VILLAGE OF LOMBARD
REQUEST FOR BOARD OF TRUSTEES ACTION
For Inclusion on Board Agenda

TITLE: PC 06-27: 101-125 S. Main Street (DuPage Theatre)

SUBJECT: **PC 06-27: 101-125 S. Main Street (DuPage Theatre)**

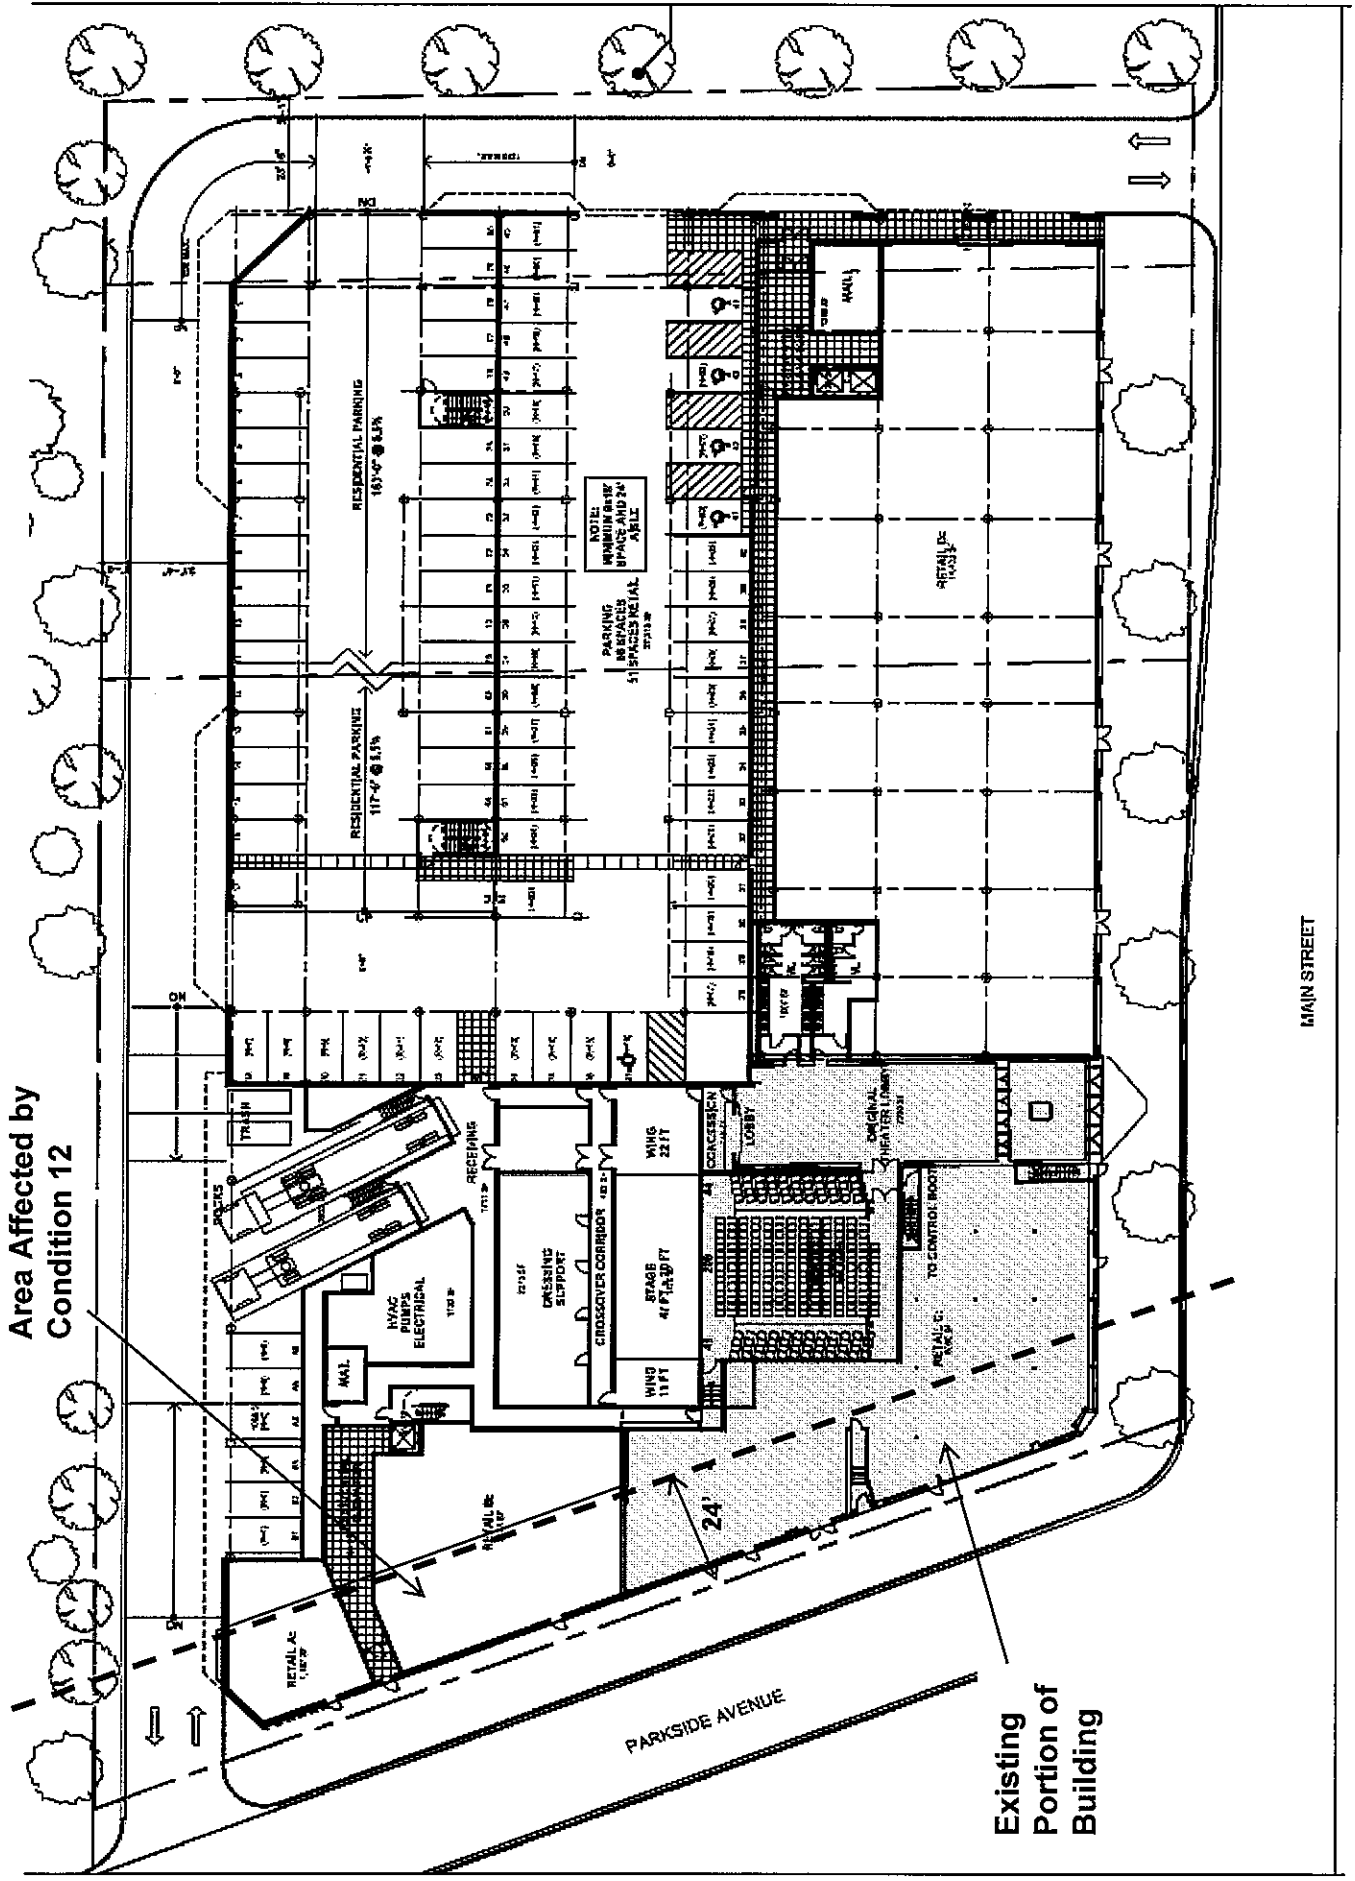
Commissioner Sweetser noted that the submitted plans denote a twenty-three foot, six inch (23'6") drive aisle plus five feet (5') for transitional landscaping along the east property line, but

the plans did not denote the dimension for the bump out (bay windows and/or balconies). Mr. Hulseberg reiterated that the motion that was made is confusing and recommended that it be amended because it applies along Parkside Avenue and not along the east property line.

Mr. Hulseberg stated that the motion as written did not do what the Commissioners it to do. If the intent was a setback of eight (80) percent of thirty feet (30'), the proposed condition is moot, as it already meets that standard. Commissioner Sweetser stated that the condition was not intended for Parkside. If the drawings had indicated the measurements of the overhang along the east property line, it would have made the issue clearer. Mr. Hulseberg noted that no part of the building is closer than twenty four feet (24') off of the east property line.

Staff prepared the attached exhibit that depicts what the building footprint would look like if condition number 12 was adopted by the Board as recommended for approval by the Plan Commission.

Staff notes that condition number 12 would modify the building footprint, the exterior elevations and the overall scope of the project. If the Board believes that condition number 12 should be included as part of the Ordinance of approval, staff recommends that the petition be remanded back to the Plan Commission for further review and the petitioner should be directed to prepare revised exhibits to reflect compliance with condition number 12. However, as noted above, the intent of the Commissioners was not to change the building setbacks along Parkside Avenue. Therefore, based upon this discussion, if the Board votes to approve the project, staff recommends that condition number 12 not be added within the conditions of approval.

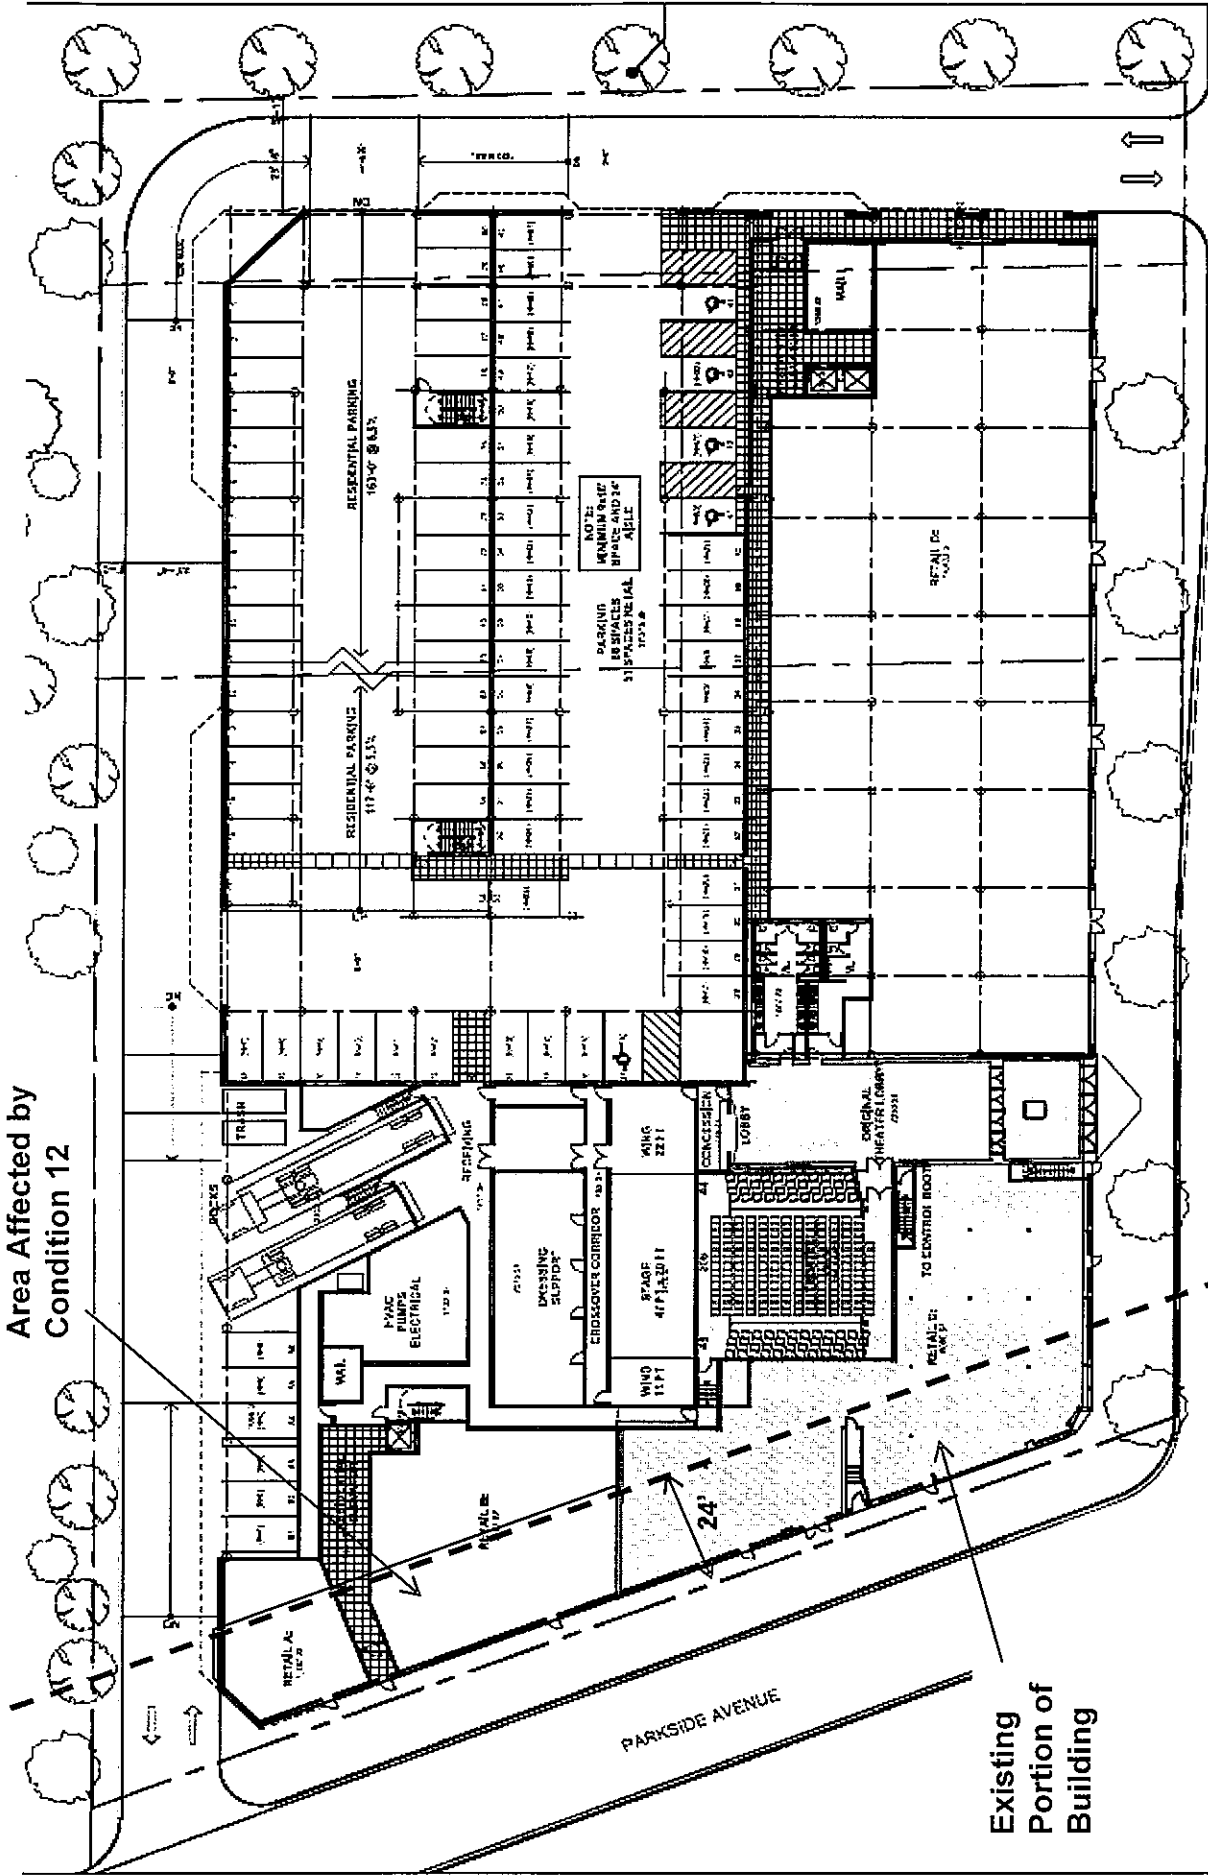
Mr. Hulseberg stated that the motion as written did not do what the Commissioners it to do. If the intent was a setback of eight (80) percent of thirty feet (30'), the proposed condition is moot, as it already meets that standard. Commissioner Sweetser stated that the condition was not intended for Parkside. If the drawings had indicated the measurements of the overhang along the east property line, it would have made the issue clearer. Mr. Hulseberg noted that no part of the building is closer than twenty four feet (24') off of the east property line.

Staff prepared the attached exhibit that depicts what the building footprint would look like if condition number 12 was adopted by the Board as recommended for approval by the Plan Commission.
